Product Change Notification

PCN-PCC-1298-2018

Business Unit	Product Line Code	Type of Change	Action	Date of Issue
PCC - PCB Connectors	AAA	Product Change Notification	Notify Distributors and Field	2/21/2018

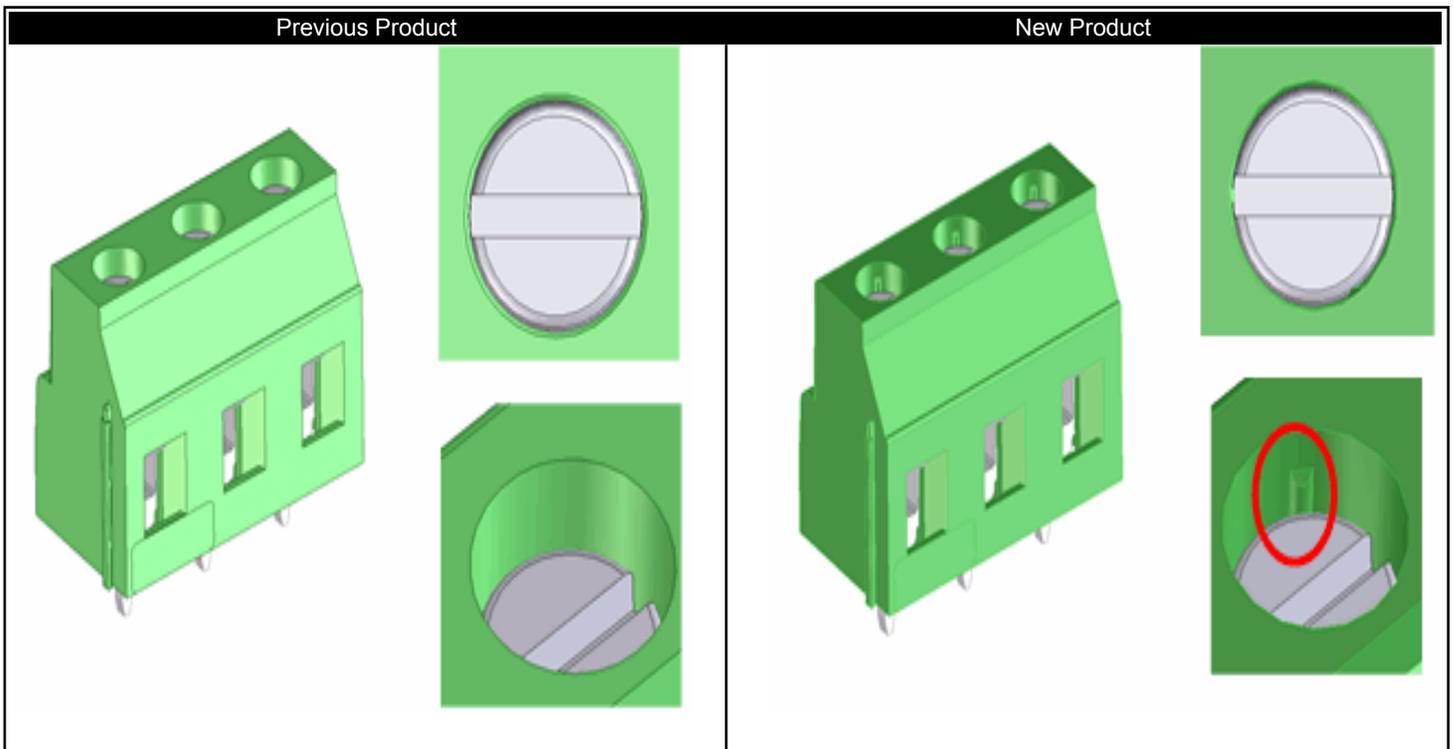
Due to our continuous improvement process the articles listed on this document will be delivered with an additional screw brake. Three plastic fins are inserted in the screw shaft to help prevent the closing of the clamping space during transportation. Dimensions and technical data remain the same. During the conversion period both versions will be delivered depending on the inventory. New versions will be identified by a change in version code (V/C) as shown on the attached spreadsheet, and are expected to begin shipping by June 1, 2018.
